<b>JRPP No. 2012SYW076</b>
----------------------------

**Proposal:** Section 96(2) Modification Application proposing modifications to Development Consent No. 166.1/2010 approved for a mixed-use development within 6 multi-storey buildings comprising a medical centre, offices and 140 residential apartments and associated car parking and landscaping

**Location:** Lot 10, DP 1061484, No. 368 Hamilton Road and Lots 1-3, DP 1083074, No. 80-84 Tasman Parade, Fairfield West

**File No:** DA 166.1/2010

Apartment - '3f'  
Total 139 sqm (106 + 33)

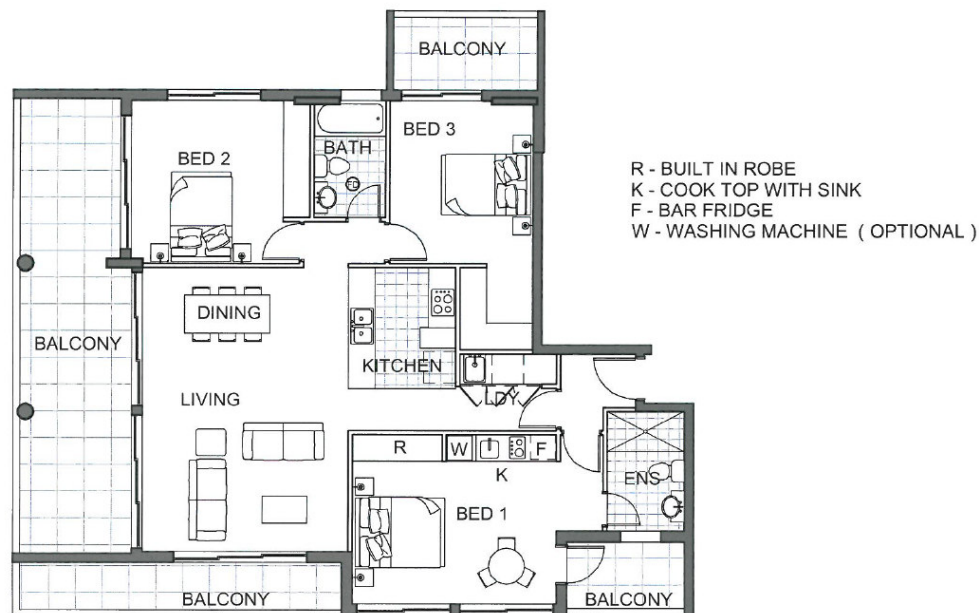
With respect to the proposed dual key apartments, concerns are raised in relation to the additional potential for overlooking of the neighbouring properties. However, the fundamental issue with the dual key apartments relates to additional traffic and parking implications. Dual key apartments are ones that provide for a separate lockable living area within the one strata titled unit. This separate living area may be subleased by the unit owner or may be occupied by family members. In this case, the second apartment contains an ensuite, kitchenette and combined bedroom / lounge area and a separate balcony. Below is an example of a proposed dual key apartment.

By virtue of their nature, organisation and purpose, the proposed dual key apartments are characterised as two (2) separate apartments. The applicant was advised that each dual key apartment is regarded as 2 separate apartments unless it can be satisfactorily demonstrated otherwise through a traffic and parking assessment report that dual key apartments do not generate additional car parking spaces.

It is proposed to provide only 1 car space for each dual key apartment. The applicable off street car parking rate per unit under Fairfield City Wide DCP – Chapter 12 is 1 car space per unit and an additional 1 car space per 4 units for visitor car parking.
